INDESIT company

Model type:
LV640ABK

Commercial code:
F029942

n1045069: Modification of racks and dispenser lid on EVO3 dishwashers

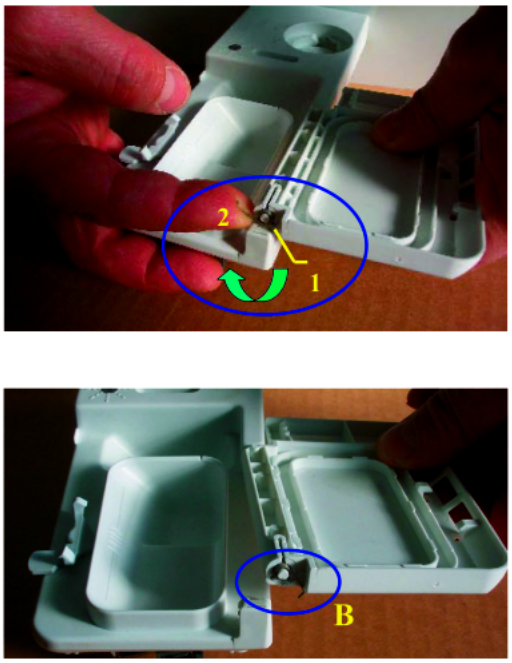
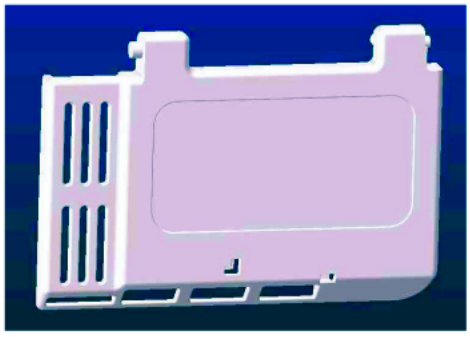
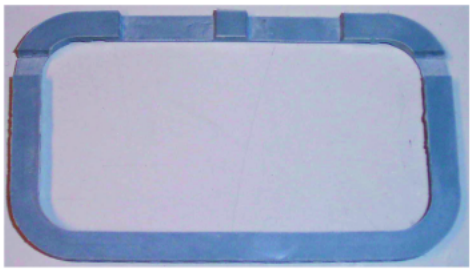
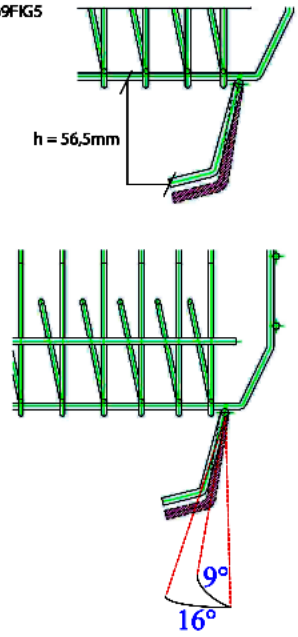
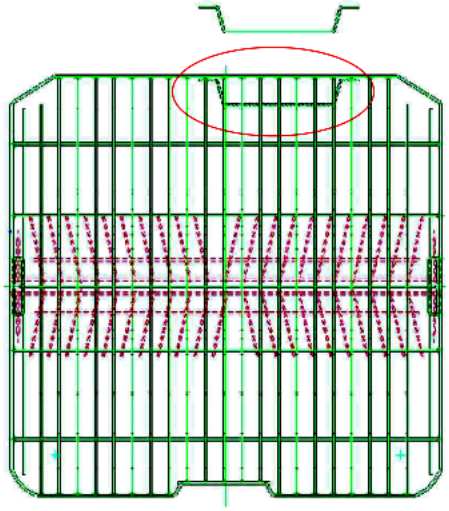
To obtain better dissolving of the detergent during the wash cycle, the following modifications have been made to EVO3 dishwashers:
- new dispenser lid, replacement code 098134 (see figure N1045069FIG4) created;
- upper racks modified with lid catch angle changed from 9° to 16° (see figure N1045069FIG5);
- MultiSystem lower racks modified with insertion of a spacer wire at the electric dispenser (see figure N1045069FIG6).

Lid installation instructions:
1) prise the lid out of the dispenser seat using a small screwdriver at point A (figure N1045069FIG1);
2) replace the lid, checking that release spring B (figure N1045069FIG2) is in place; before fitting the new lid load the spring from position 1 to position 2 (figure N1045069FIG2);
3) fit the lid in its special seat and check for correct operation (figure N1045069FIG3).
Lid closing may be harder for the first few cycles after replacement, due to settling of the material.

The upper and lower racks have the same spare part codes as the premodification items; Replacements Warehouse stocks have been replaced.

N1045083FIG1

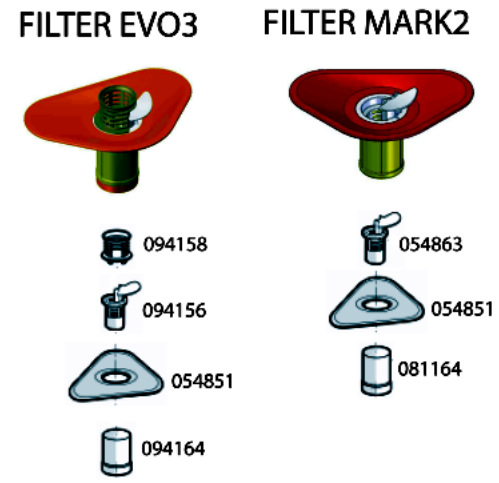
All dishwasher models affected by this modification have been equipped with the items listed below, in order to solve the drain pump clooging problem.

Introduction of:
Cylindrical plastic filter code 081164
Central filter code 054863

Elimination of:
Cylindrical plastic filter code 094164
Central filter code 094156
Central filter grid code 094158

The modification has been introduced progressively, starting from serial no. 40516.0001.

n1045085: Introduction of new litre counter turbine integrated on air-break.

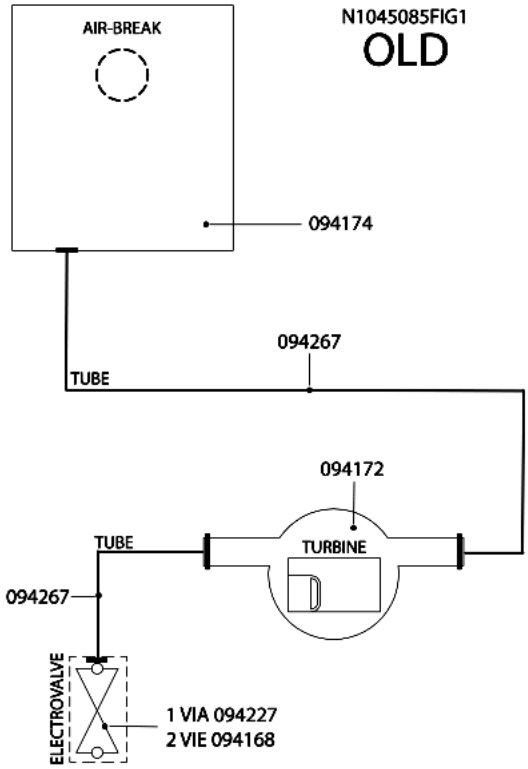
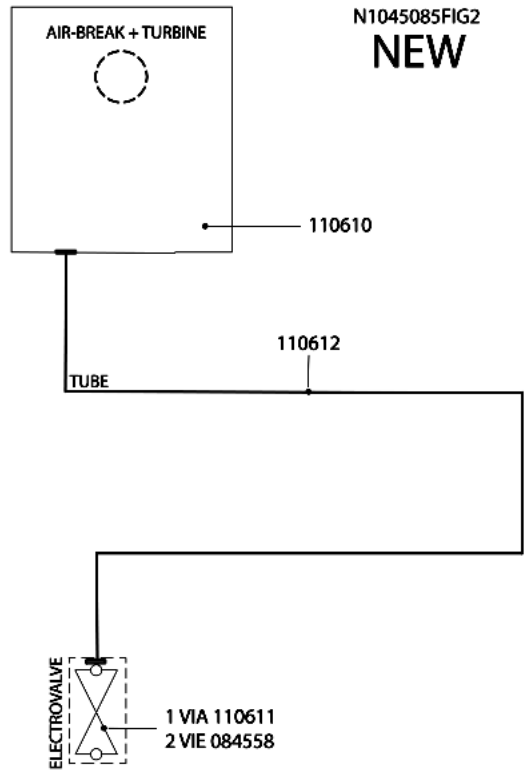
All dishwashers affected by this note have been equipped with a new litre counter turbine on the air-break.
Picture N1045085FIG1 illustrates the premodification structure, picture N1045085FIG2 the new structure.

AIR-BREAK:
new 110610;
premodification 094174;
the new item features a new integrated litre counter turbine and its water supply hose has a smaller diameter.

LITRE COUNTER TURBINE code 094172 has been eliminated.

SOLENOID VALVES:
new:
1-WAY code 110611;
2-WAY code 084558(Rohs 143737);
premodification:
1-WAY code 094227;
2-WAY code 094168;
the new solenoid valves have a smaller diameter drain hose fitting.

HOSES:
new solenoid valve hose/air-break code 110612;
premodification turbine hose/air-break code 094267;
premodification solenoid valve hose/air-break code 094267;
the new hose has a smaller internal diameter.

WIRING:
the litre counter turbine connecting cable is longer, but since the connector is the same, the new item can be used in place of the premodification one.

N1045093FIG1
NEW FLAP UPPER BASKET SAT CODE 114799

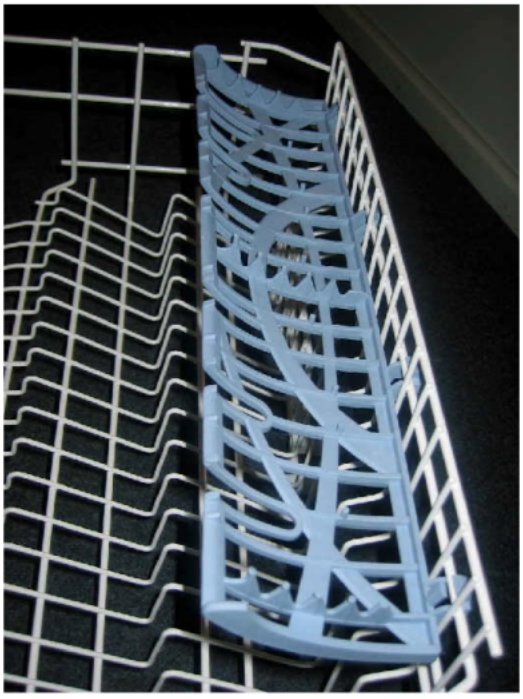
From serial no. 41109.0001 all models affected by this bulletin feature a modification of the folding shelf to upper basket coupling system.
This modification called for alteration of the relative baskets: the distance between the wire on which the folding shelf is attached and the wire below it has been increased from 9.5 mm to 17 mm, as shown in the attached image.
The altered folding shelves are not interchangeable and cannot be installed on premodification baskets: in the case of service interventions on product with serial number prior to 41109.0001 the entire upper basket must be replaced.
The baskets are reciprocally interchangeable and are managed as assemblies complete with their accessories, inclusive of folding shelves.

UPPER BASKET LIGHT BLUE FOLDING SHELF
new 114799 - premodification 094140.

UPPER BASKET ASSEMBLIES
new 115001 - premodification 094139;
new 115002 - premodification 094222;
new 115003 - premodification 094233.

N1045076FIG1

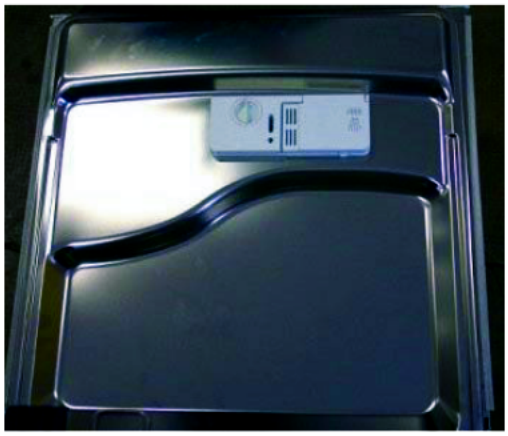
From serial number 50930.0001, to solve the problem of water spurts emitted from the lower right and left side of the door the following modifications were introduced in production:

1-Airbreak without insert to allow the necessary pressure venting

2-Honeycomb top panel to protect the kitchen unit from any steam emitted (only on built-under models)
3-Tank seal length increased by 3 cm to improve water tightness
4-Die-cut roof sound-deadening panel
5-Three clips for correct fixing of the tank base seal (in production from serial number 50701.0001)

New parts:
C00141308 - Airbreak
C00141310 - Honeycomb top panel (built-under versions only)
C00141317 - Tank seal
C00141314 - Roof sound-deadening panel
C00140679 - Tank base seal fixing clip

Premodification parts
C00110610 - Airbreak
C00116110 - Tank seal
C00097300 - Roof sound-deadening panel

1) AIRBREAK REPLACEMENT
It is mandatory to use the new part; in the event of replacement with premodification appliances proceed as follows:
- replace the airbreak with the new part C00141308
- if present, refit the roof sound-deadening panel after cutting out a 10x10 cm square from the rear left-hand corner
- on the built-under version, fit honeycomb panel C00141310 on the top of the appliance
- replace tank seal with the new seal P/N C00141317

2) CHANGING THE TANK SEAL
On appliances with serial number from 40101.0001 to 50930.0001, you can use the new tank seal P/N C00141317 after cutting 1.5 cm off each end.

N1045133/134FIG1

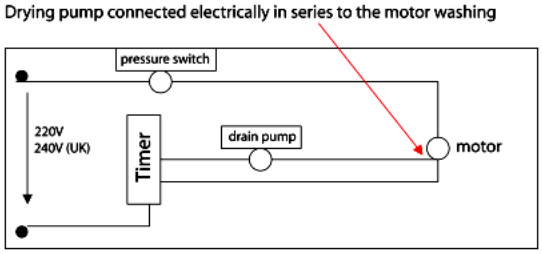
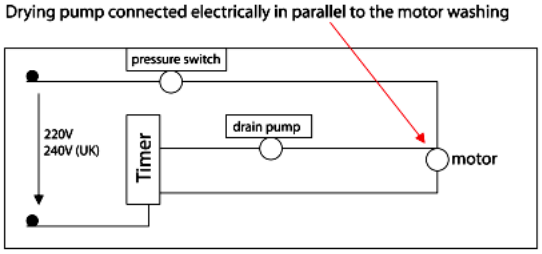
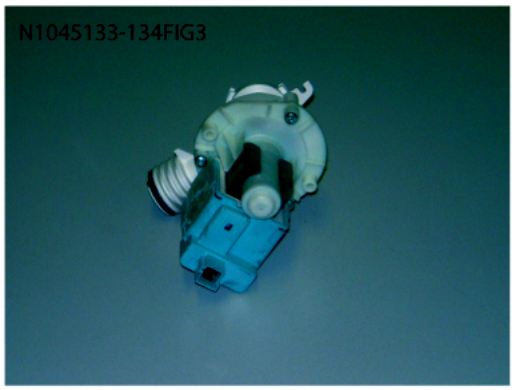
The drain pump electrical connection has been modified from a configuration in series with the wash electric pump to one in parallel.

The drain pump in series with the wash electric pump is fed through the wash electric pump causing a voltage drop equal to -15V (diagram N1045133-134FIG1).

The drain pump in series with the wash electric pump is electrically fed directly by the F-N line, without any voltage drop (diagram N1045133-134FIG1).

New parts:
Wiring in parallel
C00118767(Rohs 143766) - thermoprotected drain pump 220/240V 50HZ 26W - picture (N1045133-134FIG3)

Premodification parts:
Wiring in series
C00112306(Rohs 143739) - drain pump 230V 50HZ 22W - picture (N1045133-134FIG4)

Important!!
The thermoprotected drain pump cannot be installed on premodification dishwashers.
The non-thermoprotected drain pump cannot be installed on modified dishwashers.

N1045136FIG1

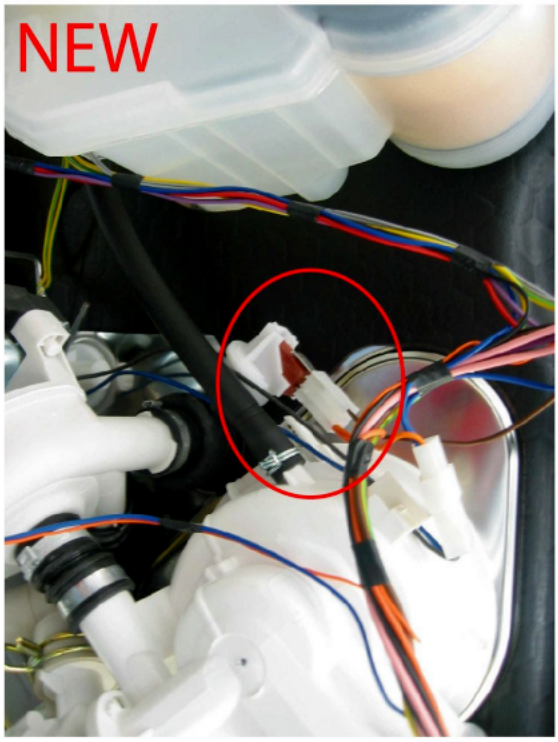
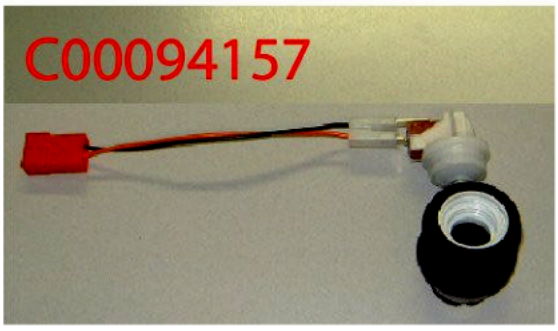
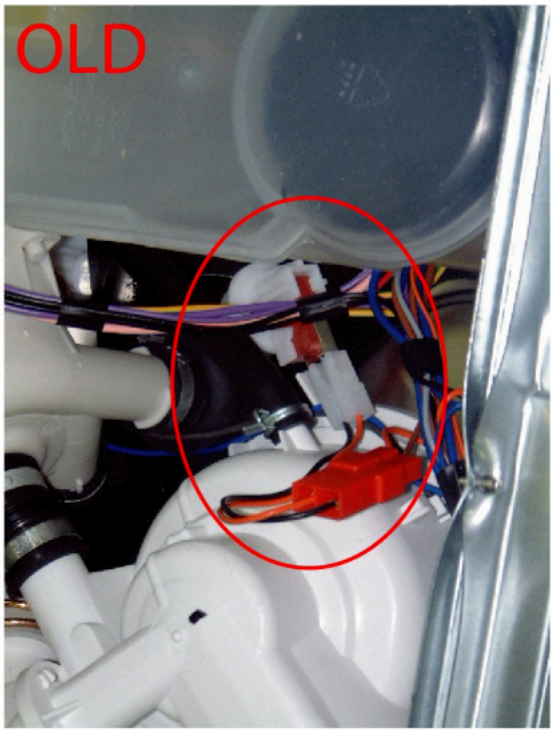
In modified products the connector going to the high pressure sensor is part of the wiring assembly (see picture N1045136FIG1). In premodification products the high pressure sensor is connected to the wiring assembly by a cable that is part of code C00094157 (see pictures N1045136FIG2-3).

New parts
Wiring
C00142435 - high pressure sensor

Premodification parts
Wiring
C00094157 - high pressure sensor + cable

The new parts are not individually interchangeable with premodification ones.
